DCN No.	E010092-00-D		
SHEET	1	OF	1
5/10/01

DOCUMENT CHANGE NOTICE (DCN)

DOCOME	INT CHANGE NOTICE (DCN)			
DOCUMENT No. (DOC-REV-GP. ID)	TITLE	<u> </u>	NEW REV.	
LIGO-E010091-00-D	Chamber Component Configuration HAM1 MAR/APR 2001 Continued			
CHANGE DESCRIPTION (FROM/	Official Release. Rev. change from 00 to	A.

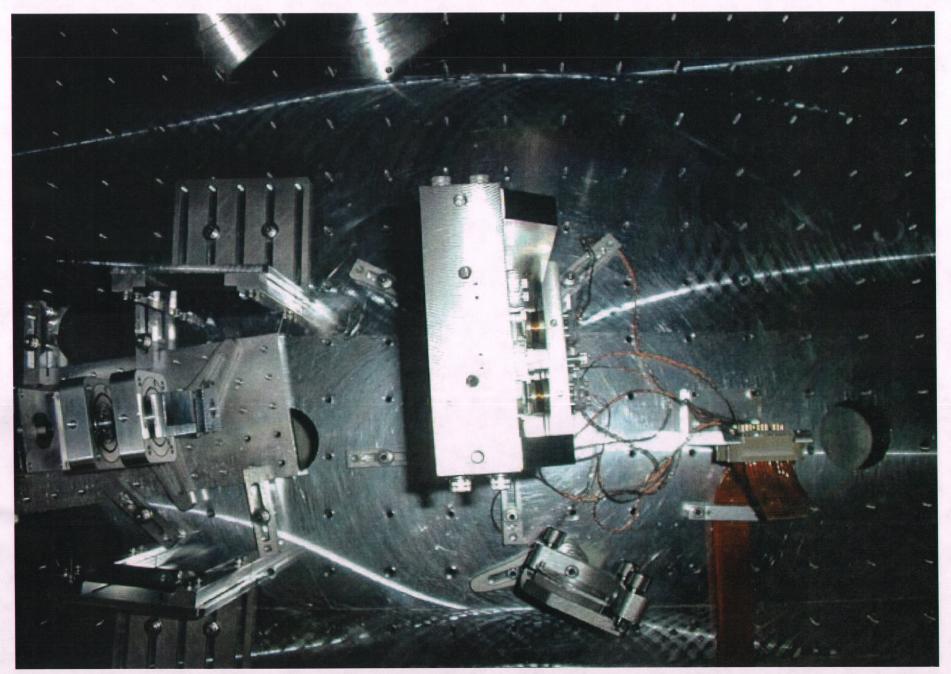
(A)				
REASON FOR CHANGE: Upda	ted for 4k Detector Installation			
		100 CH (100 CH	199,	
ACTION: Incorporate chang	e Attach DCN to drawing(s) Other action (specify):			
DISPOSITION	OF HARDWARE (IDENTIFY SERIAL NUMBERS)	DCN DISTRIBUTION (X=in	icl. docs)	
No hardware affected (reco			Coles	
List S/Ns which comply alre	■ 11 (3) (2) (3) (3) (4) (4) (4) (4) (4) (4) (4) (4) (4) (4	Sanders Shoemaker Tyler Weiss		
List S/Ns to be reworked or	H1. 20. 194 (A.M.) 4			
List S/Ns to be built with th				
List S/Ns to be retested per	X Reitze X Tanner			
SAFETY, COST, SCHEDULE, REC	QUIREMENTS IMPACT? No Yes (If yes, enter Change	Request number)	
APPROVALS	+	OVALS (specify)	DATE	
ORIGINATOR: B. Weaver	13. We gray 18 bord 10 [27 0]			
TASK LEADER: S. Whiteon		POLICE AND A STATE OF THE STATE		
DCC RELEASE: Whitcon				
DUC HELEASE: WILLA	n 11.11.01
